Access Compliance Report

Public Rights-of-Way

(Curb Ramps)

Intersection ID: 2907	Main Street: EVERGREEN_HOLLOW_DR	Cross Street: GOLDENFIELD_DR	Location:	N
ADA ID: 35421EBBF61D	Ramp Type: Perp	Initial Pass/Fail: Fail	Overall Compliance: No	Severity Score: 33.75
Codes/Mitigation Info/Possible Solution		Field Measurements/Component Compliance

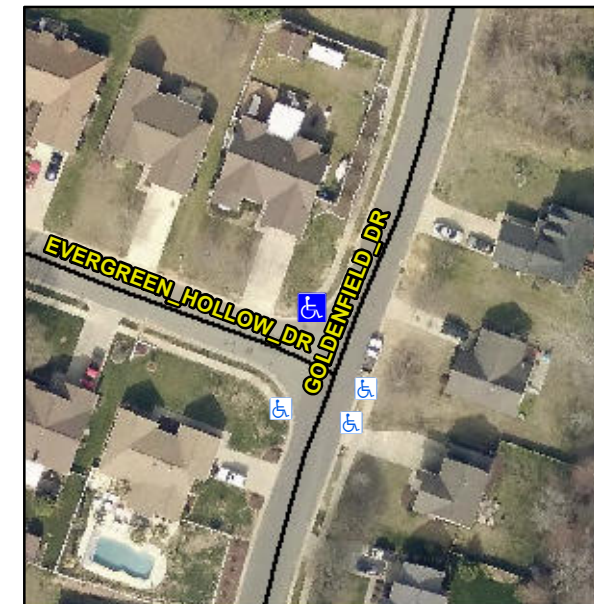
Not Found, R304.5.1, R304.2.2

Compliance	Description	Data	Compliance	Description	Data
N/A	Ramp Length (in)	48.0	No	Ramp Slope (%)	13.8
No	Ramp Width (in)	43.0	Yes	Ramp XSlope (%)	0.6
N/A	Flare Type LT	N/A	N/A	Flare Type RT	N/A
N/A	Flare Slope LT (%)	N/A	N/A	Flare Slope RT (%)	N/A
N/A	Flare Traversable LT?	N/A	N/A	Flare Traversable RT?	N/A
N/A	Landing Length (in)	N/A	N/A	DWS Provided?	N/A
N/A	Landing Width (in)	N/A	N/A	DWS Contrast?	N/A
N/A	Landing Slope (%)	N/A	N/A	DWS Length (in)	N/A
N/A	Landing X Slope (%)	N/A	N/A	DWS Full Width?	N/A
N/A	Landing Curb? (Y/N)	N/A	N/A	DWS Offset (in)	N/A
N/A	Shared Landing?	N/A			
N/A	Gutter Ponding?	N/A	N/A	Gutter Slope (%)	N/A
N/A	Gutter Lip Ht (in)	N/A	N/A	Gutter X Slope (%)	N/A
N/A	Painted X Walk1?	No	N/A	Painted X Walk2?	N/A
	X Walk 1 Direction	To SW		X Walk 2 Direction	N/A
N/A	X Walk 1 Width (in)	N/A	N/A	X Walk 2 Width (in)	N/A
	X Walk 1 Slope (%)	2.8		X Walk 2 Slope (%)	N/A
	X Walk 1 X Slope (%)	1.4		X Walk 2 X Slope (%)	N/A

Remove & Replace Entire Ramp.
